Item 939

70. REAR BRAKE JUDDER

MAESTRO (EXCEPT VAN),  
& MONTEGO

Item 940

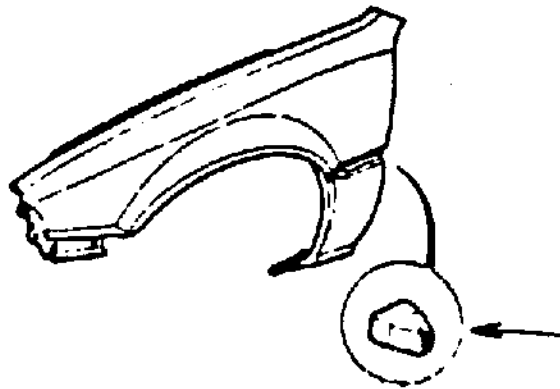
Problem: Excessive flexing of rear edge of front wing  
and/or

Front edge of front door fouls wing.

Action: Check that rubber wedge, wing to 'A' post is correctly positioned. Open front door and examine gap between rear edge of front wing and 'A' post. Rubber wedge should be behind and adjacent to wing finisher strip. If it is adrift or missing, it will be necessary to remove 3 screws at rear lower edge of wheel arch liner to gain access to refit, or fit new, rubber wedge - see diagram.

Part number: DBP 6996 - Stopper, front fender
